U.S. Department
of Transportation
**Federal Aviation
Administration**

Subject: Federal Aviation Administration (FAA) Approval of an Alternative Method of Compliance (AMOC) to Airworthiness Directives (AD) 2008-11-13, 2012-07-06, 2014-09-09, 2015-17-13, 2016-11-07, 2016-11-16 and 2015-25-08

References: (1) Boeing letter DLD4-21-00060, dated March 16, 2021
(2) Boeing 777 Maintenance Planning Data (MPD) Document, Section 9, D622W001-9, dated February 2021 (Watermark Not FAA Approved 3/12/2021 02:14 PM)
(3) Boeing 777 28-AWL-31 and 28-AWL-32 Revision—Teflon Sleeve & Cushion Clamp Assessment, D340W105-23, dated February 26, 2021

FIGURE 1. FLIGHT LENGTH SENSITIVE (FLS) THRESHOLD CURVE (777-200/200LR/300/300ER ONLY)

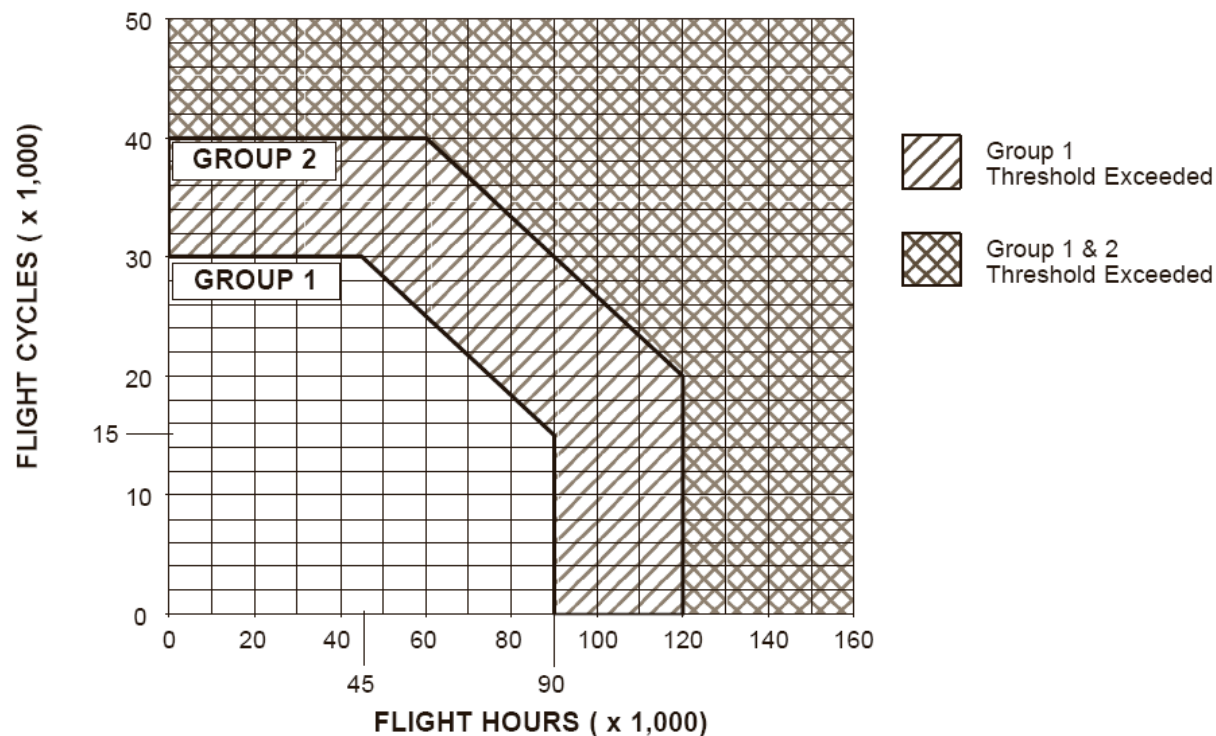
Revised Section B., Airworthiness Limitations - Structural Inspections, Figure 1 to include the 777-300.

FIGURE 5. 777-200LR/300ER/777F MAIN LANDING GEAR SAFE-LIFE LIMITS

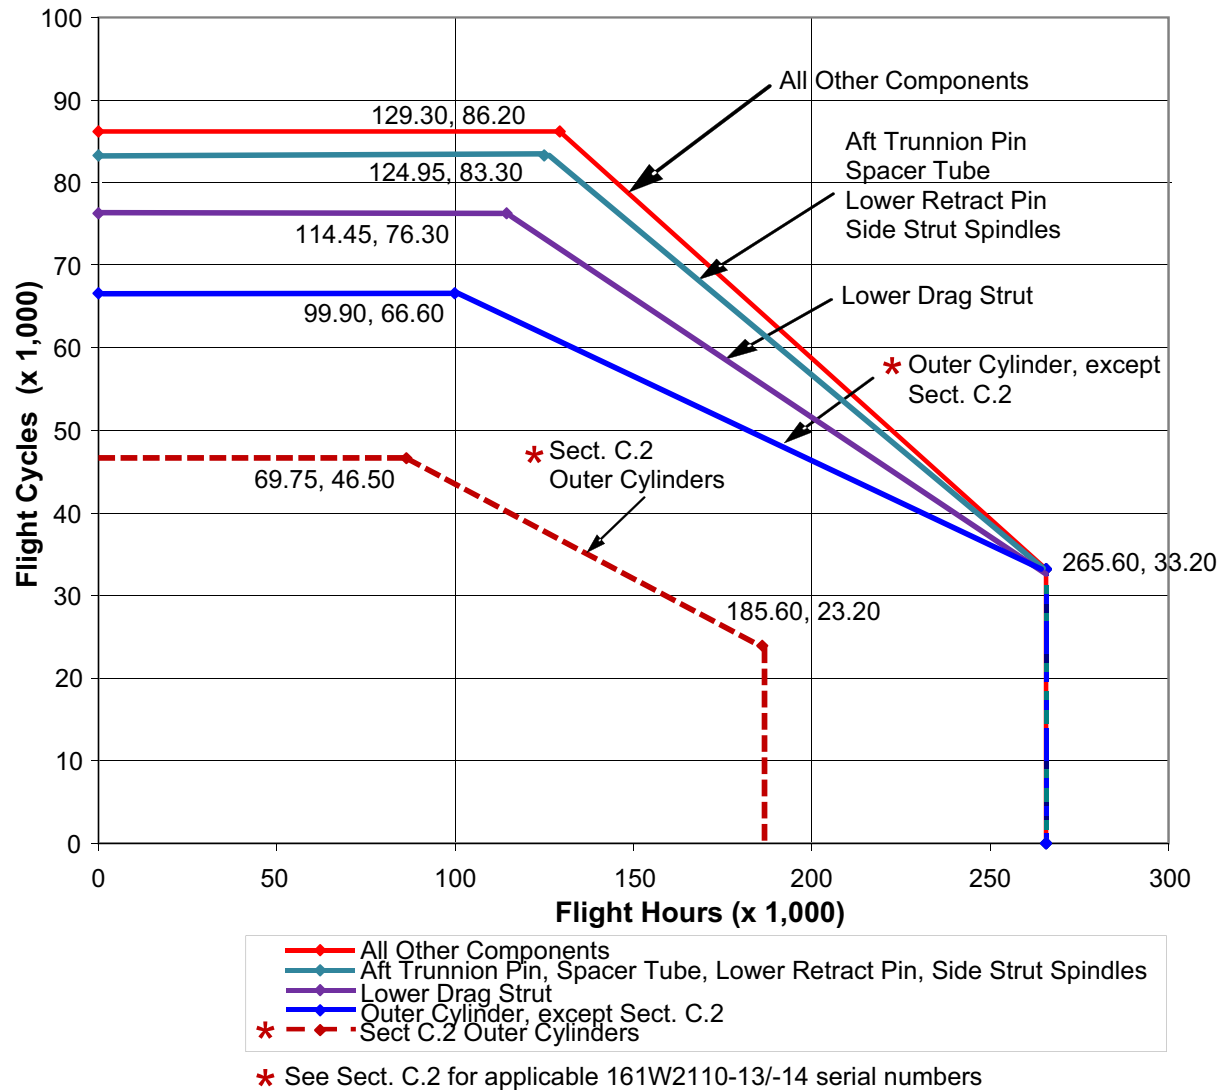
Revised Figure 5: 777-200LR/300ER/777F MLG Safe-Life Limits to reflect the addition of the life limit curve for outer cylinders as indicated in Section C.2.
